Rainbow SkyReach (Pty) Ltd

SAFETY DIRECTIVE

IMPORTANCE	HIGH
AREA AFFECTED	SEAT-BELT
SA/D NUMBER	CH 016-11-2021
EFFECTIVE DATE	5 November 2021

Figure 1: Belt Pulled Horizontal by Seat being pushed Forward (Stitching area to inspect shown by red arrow)

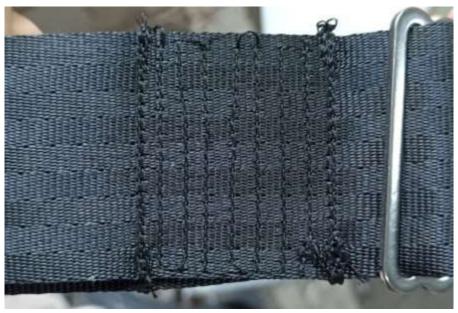
All BushCat/Cheetah XLS aircraft with serial number lower than CH-277C, with the 'X' style stitch pattern (visible in Figure 1). Belts with the new stitching pattern (visible in Figure 2) can ignore this directive.

- 1. To aid in the inspection, push the backrest of the seat forward, as this will help show the area of concern.
- 2. Inspect the area of the join of the vertical segment of the seatbelt, and the shoulder-harness section that runs (almost horizontally, when the backrest is pushed forward) over and down the seat (see Figure 1).

- a. Inspect the general quality of the stitching for any signs of fraying or unravelling of the stitching that joins the belt sections.
 - b. From below, inspect the join area where the shoulder-harness section moves horizontally away for separation. This is the critical area of failure (see Figure 3).

- 3. If the belt is in good condition, without signs of fraying or separation, the aircraft can be flown as usual. The inspection step should be repeated as part of every preflight inspection.

- 4. If there are signs of fraying and/or separation, please contact your distributor/the factory immediately in order to obtain a replacement seatbelt, and do not fly in that seat until the part has been replaced.
